2131 Pittwater Road, Church Point

Geotechnical Comments for Section 4.55 Plans

We have reviewed the existing geotechnical report, the original plans, and the 15 amended plans by CHROFI, project 25002, drawings numbered DA501, revision 01. DA000 to 001, DA 100 to 103, DA200 to 201, DA300 to 301, DA400, DA500, and DA502 to 503, revision 03. All dated 24/06/2025.

GEOTECHNICAL INVESTIGATION:

TYPE SECTION – Diagrammatical Interpretation of expected Ground Materials

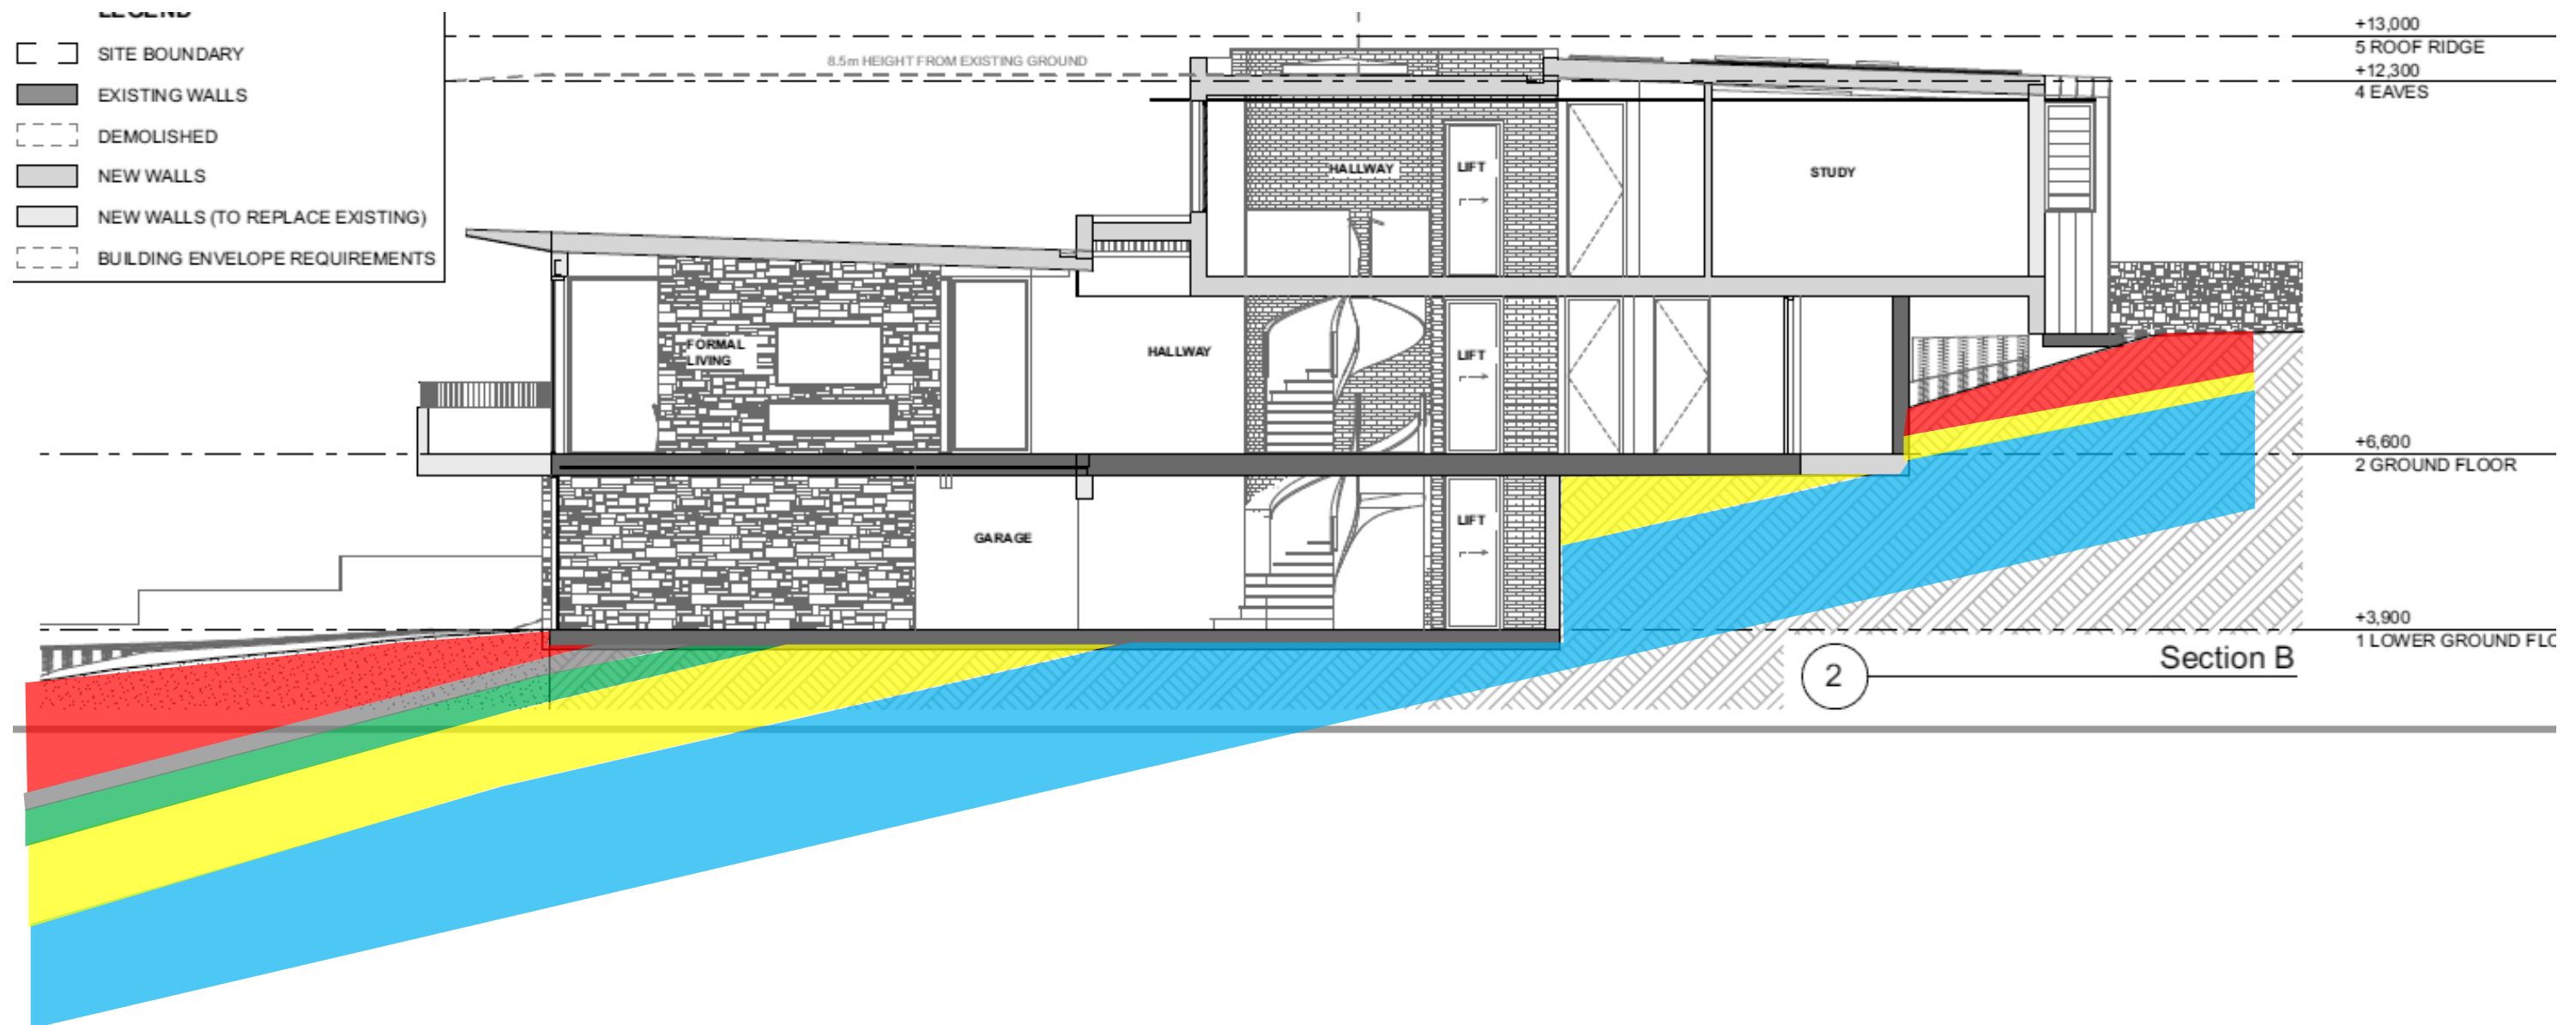
The natural slope materials are colluvial at the near surface and residual at depth. In the test locations, the ground materials consist of younger sandy clay alluvial sediment at the downhill boundary which overlies deep weathered clay. Filling has been placed across the property for landscaping. The clays merge into the weathered zone of the underlying shale at depths of between 2.4m to 3.9m below the current surface on the downhill side of the house, and depths of 0.3m to 1.2m on the uphill side of the house. This variation in depth is due to the fills and sediment on the downhill side of the property, and cuts on the uphill side, as well as a variable weathering profile. The weathered zone is interpreted as Extremely Low to Very Low Strength Shale. It is to be noted that this material can appear as a mottled stiff clay when it is cut up by excavation equipment. See Type Section attached for a diagrammatical representation of the expected ground materials.
